ASB-1048

Service Bulletin

Subject: TH-78AT IMD Improvements
2006

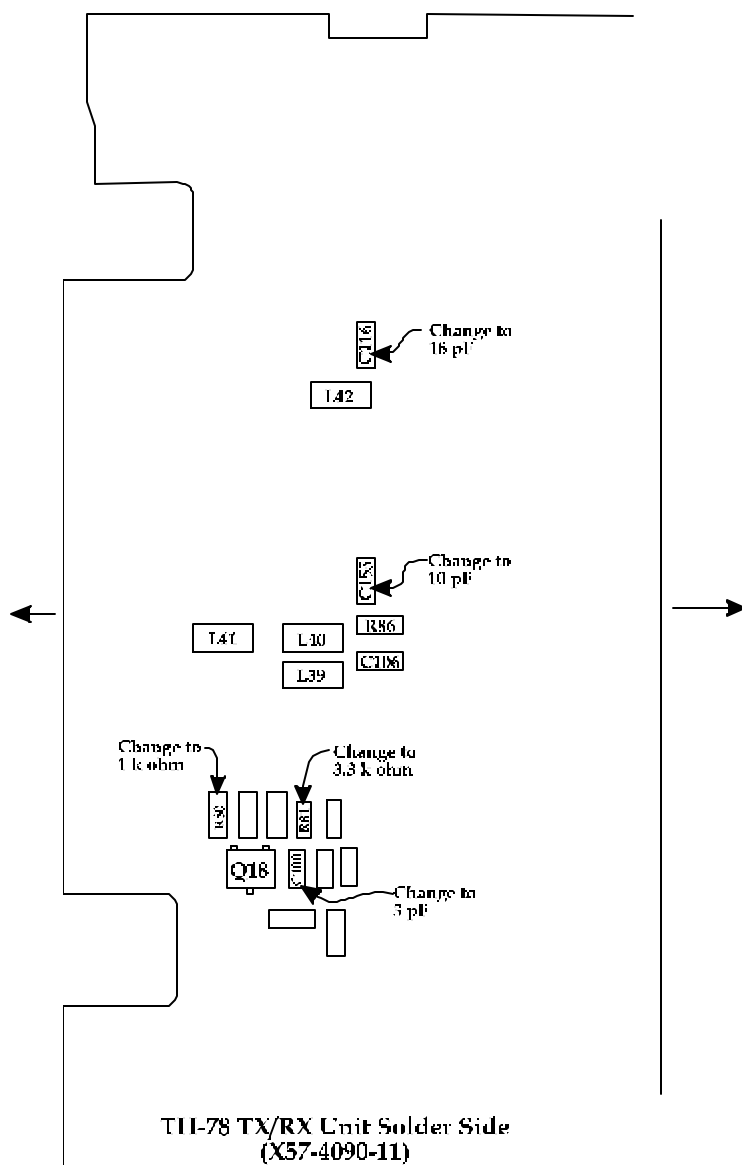
Change the components indicated in the chart and accompanying diagram on the TX-RX Unit (X57-4090 B/4) will reduce mixer currents and reduce the bandwidth of the Band Pass Filter (BPF) circuit.

Qty	Description	Old Part No.	New Part No.	Circuit Description
1	1 k Ohm chip resistor	RK73GB1J391J	RK73GB1J102J	R80
1	3.3 k Ohm Chip resistor	RK73GB1J392J	RK73GB1J332J	R81
1	3pF Chip capacitor	CC73GCH1H010C	CC73GCH1H030C	C100
1	18pF Chip capacitor	CC73GCH1H330J	CC73GCH1H180C	C116
1	10pF Chip capacitor	CK73GB1H102K	CC73GCH1H100D	C155
